# International Aero Engines SERVICE BULLETIN

ENGINE - HP COMPRESSOR RING CASE - STAGE 10 CASE ASSEMBLY  
WITH INCREASED NUMBER OF RIVETS

72-41-00

# V2500-ENG-72-0154

Location of stage 10 case assembly  
Figure 1

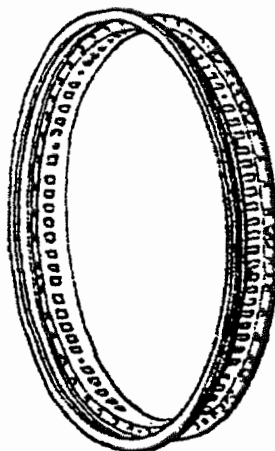
REMOVE 6A3389  
6A3393  
INSTALL 6A5436  
6A5437

REMOVE 6A4526  
6A4527  
INSTALL 6A5438  
6A5439

Section through rear HP compressor and stage 10  
compressor case assembly  
- Before and after alteration  
Figure 2

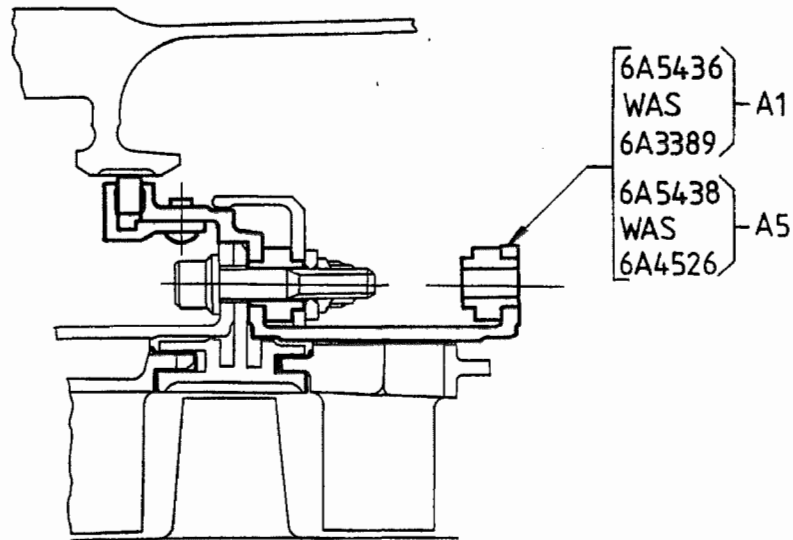
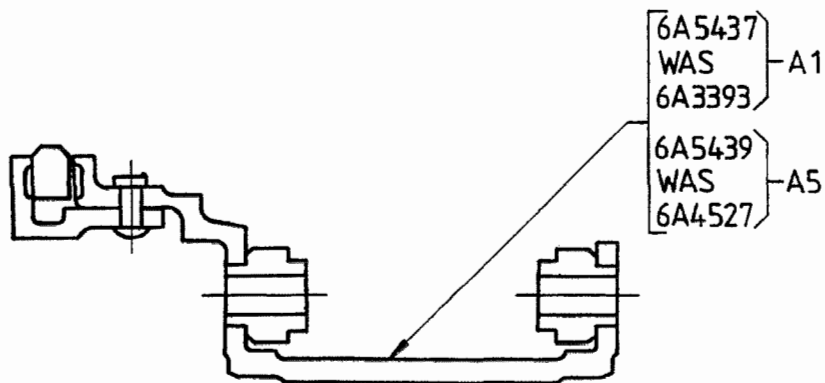
Instances have occurred where the front retainer of the stage 10 case assembly has been deflected forward following release of a number of its securing rivets.

It has been established that the rear outer casing can foul the seal assembly if it is not properly aligned during assembly. This may cause overstressing of the rivets when the outer casing is pulled into its location and lead to rivet release with attendant displacement of the seal.

The stage 10 case assembly has the quantity of rivets which secure the seal ring retainer increased from 48 to 96.

No testing is considered necessary. The increase in the number of rivets will reduce the individual rivet stress level at assembly and during engine running.

Rework of existing stage 10 compressor case assembly  
Figure 3

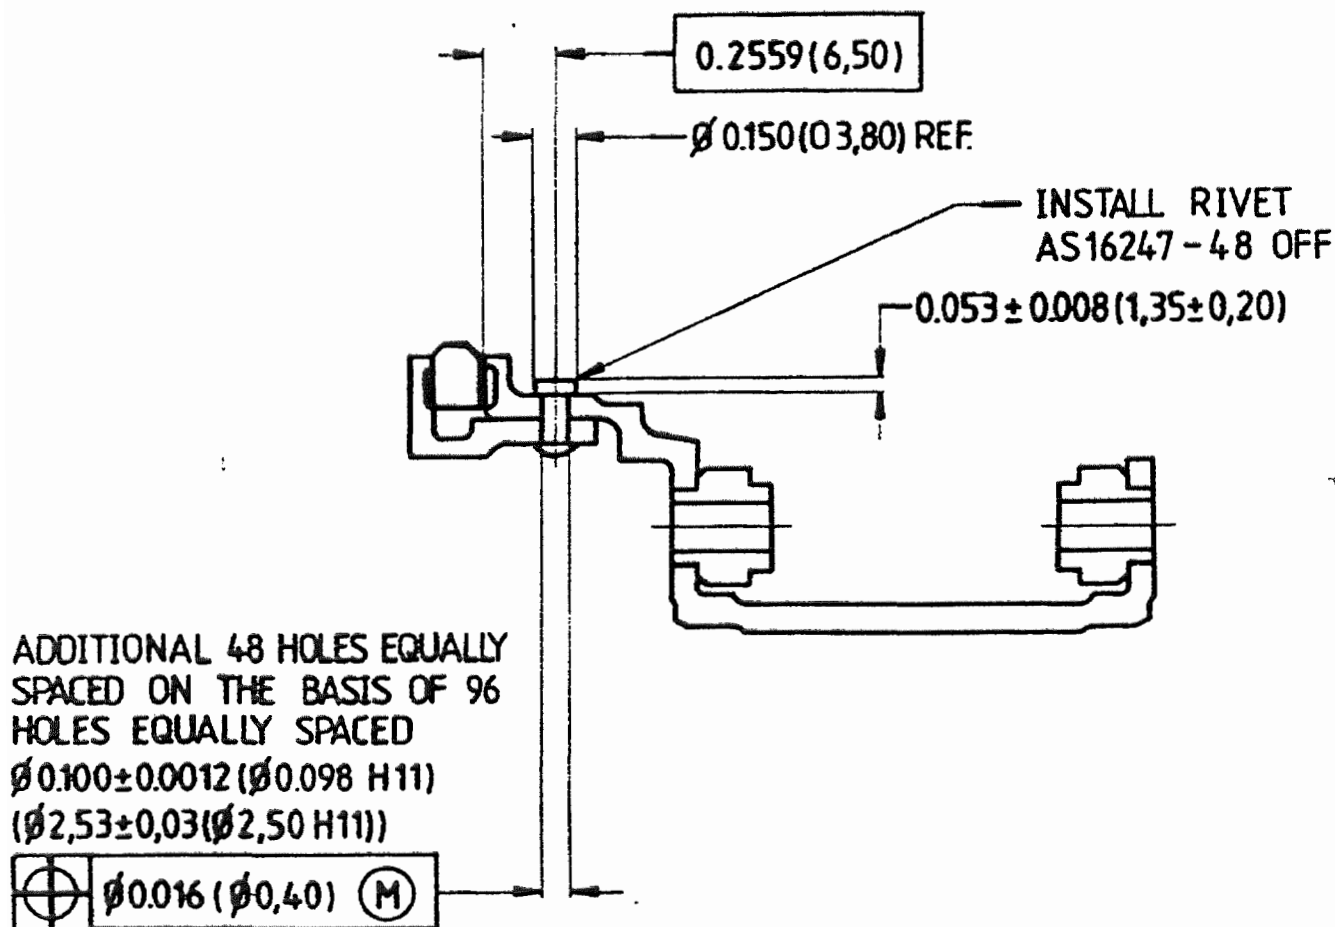
<u>Procedure</u>	<u>Supplementary Information</u>
(a) Install the casing onto the indexing table of an applicable vertical boring machine	Use standard workshop equipment
(b) Install drill into the vertical boring machine	Use standard workshop equipment and a 0.098 to 0.101 in. (2,50 to 2,56 mm.) drill
(c) Align one of the initial rivets below the drill point	Use the indexing table of the vertical boring machine
(d) Index the table 3.75 degrees	Use the indexing table of the vertical boring machine
(e) Drill one hole to size	Refer to Figure 3. Use a 0.098 to 0.101 in. (2,50 to 2,56 mm.) drill
(f) Index the table 7.5 degrees	Use the indexing table of the vertical boring machine
(g) Drill one hole to size	Refer to Figure 3. Use a 0.098 to 0.101 in. (2,50 to 2,56 mm.) drill

- | (h) Do operations (f) and (g) again until 48 holes have been drilled |  |                     |                     |        |        |        |        |        |        |        |        |
|--|--|---------------------|---------------------|--------|--------|--------|--------|--------|--------|--------|--------|
| (i) Remove all sharp edges from the new holes                        | Use standard workshop equipment  |                     |                     |        |        |        |        |        |        |        |        |
| (j) Crack test the affected areas                                    | Refer to SPM TASK 70-23-01-230-501<br>Use penetrant crack test equipment   |                     |                     |        |        |        |        |        |        |        |        |
| (k) Install the rivets into the holes at 48 positions                | Use AS16247 rivet, solid, 48 off   |                     |                     |        |        |        |        |        |        |        |        |
| (l) Cold squeeze the rivets into place                               | Refer to SPM TASK 70-39-03-390-501<br>Use standard workshop equipment  |                     |                     |        |        |        |        |        |        |        |        |
| (m) Examine  | Make sure the rivets are tight   |                     |                     |        |        |        |        |        |        |        |        |
| (n) Do a penetrant crack test on the new rivets                      | Refer to SPM TASK 70-23-01-230-501<br>Use penetrant crack test equipment.<br>Discard cracked rivet(s)  |                     |                     |        |        |        |        |        |        |        |        |
| (o) Cancel the old part number and identify with the new part number |

ALL DIMENSIONS ARE IN INCHES (MILLIMETRES)  
BREAK SHARP EDGES  $0.012 (0,30) \pm 0.008 (0,20)$  U.O.S.
